**SAFETY RECALL NOTICE****VOLVO****SAFETY RECALL RVXX0406  
APRIL 2005**

Volvo Trucks North America, Inc. has decided that a defect, which relates to motor vehicle safety, exists in certain Volvo VN and Volvo VHD model vehicles built between July 1, 2000 and June 18, 2004.

Connector (depicts before recall)

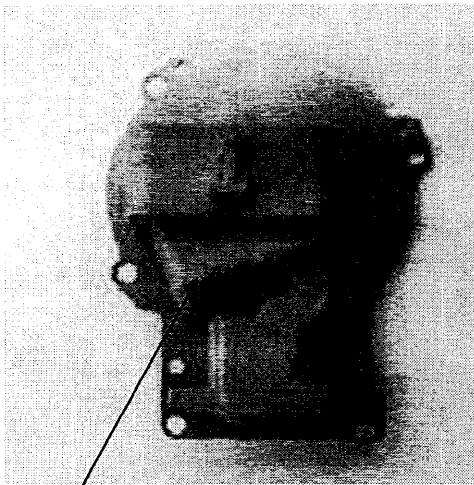
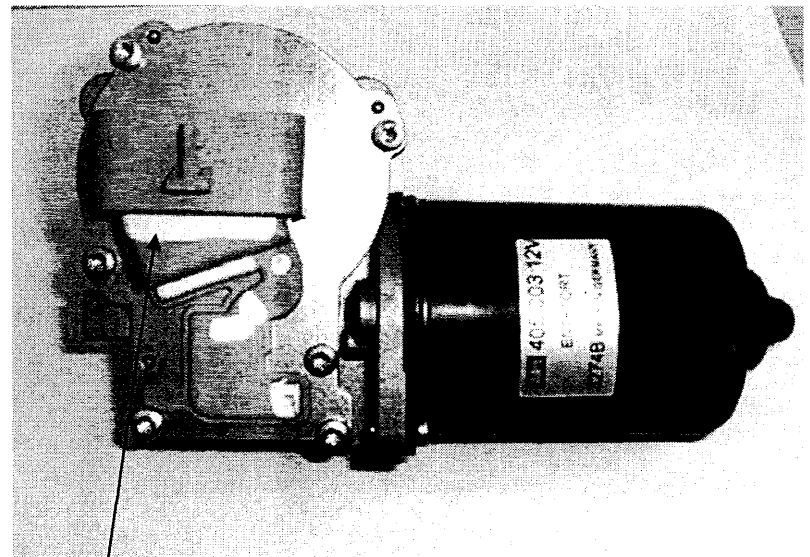
**SAFETY DEFECT:** The windshield wiper motor may be susceptible to road salt spray intrusion that could possibly lead to a wiper motor connector malfunction.

**POTENTIAL RISK:** If a wiper motor connector malfunction exists, the connector may begin to overheat, which could lead to a vehicle fire. This condition may exist with the wipers in the parked position (i.e. not in motion).

This close-up shot of the wiper motor depicts which part of the motor is the connector:

**REPAIR:** A Volvo Truck Dealer will replace the connector on the wiper motor at no charge to you regardless of your vehicle's age or mileage. The labor time required to repair your vehicle is approximately 30 minutes.

Connector (depicts recall solution)

Example of melted connector:  
(Plastic melted and charred)

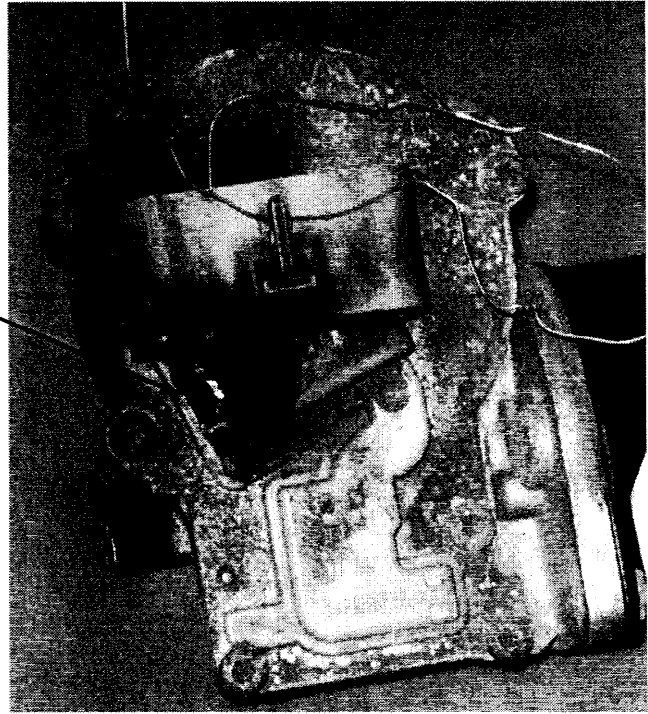
**PRECAUTIONS YOU CAN TAKE:** You can inspect the wiper motor connector for evidence of overheating (melting) to see if an overheating condition exists (see photos on the last page of this document in the section titled "Inspection"). If smoke is visible from under the rear of the hood, you should turnoff and remove the ignition key immediately! Also, idling of unattended vehicles and idling while sleeping should be avoided, particularly before the connector is inspected.

The two images below show connectors that exhibit signs of overheating:
